**TRI-LAKES MONUMENT FIRE PROTECTION DISTRICT**

To: Nina Ruiz, El Paso County  
From: Jamey Bumgarner, Fire Marshal  
Subject: Northbay at Lake Woodmoor  
Date: December 19, 2019

Please accept the following comments from the Tri-Lakes Monument Fire Protection District (TLMFPD) to reference the proposed Northbay at Lake Woodmoor.

TRI-LAKE MONUMENT SO# 3876  
 100' RM Platform  
 Turning Radius

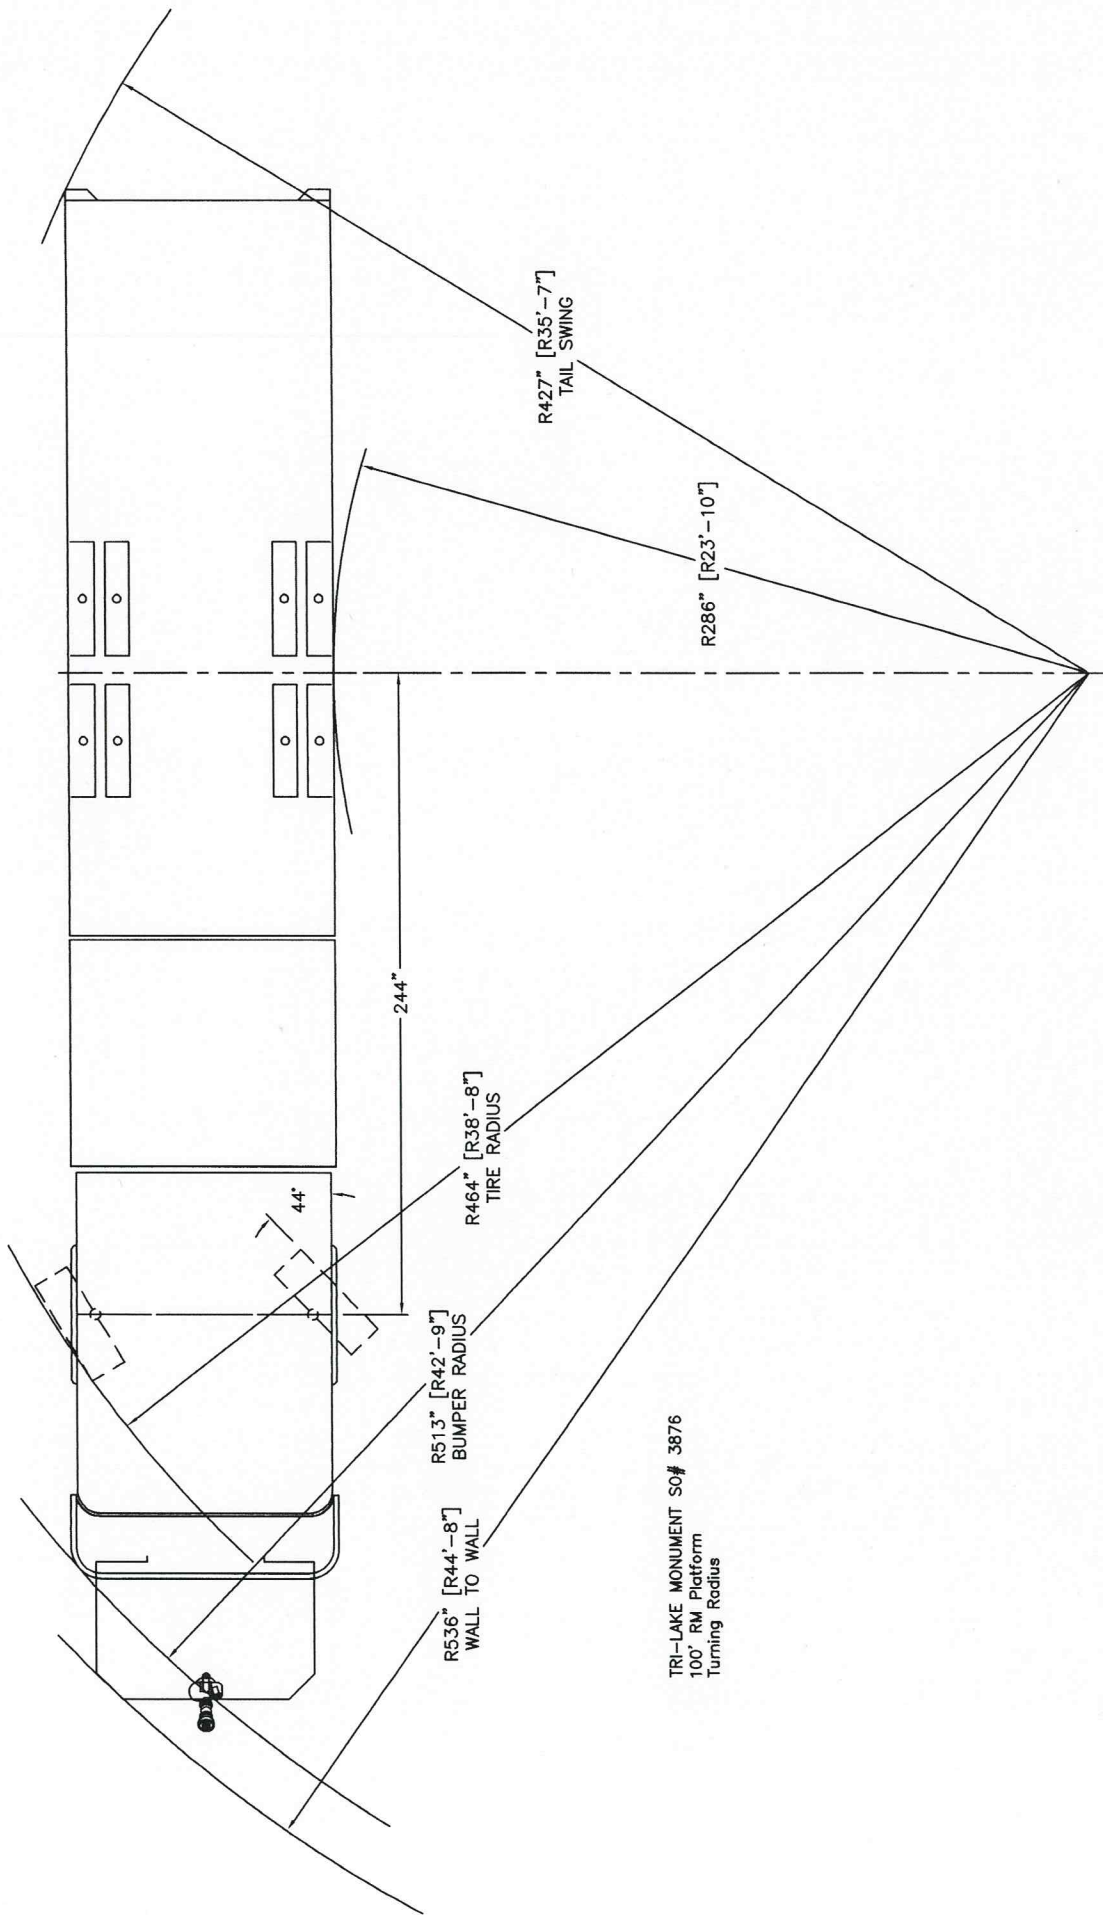
All roadways/driveways will be required to comply with Appendix D of the adopted 2009 IFC for Fire Department access and allow for the proper turning radius attached of our Ladder truck.
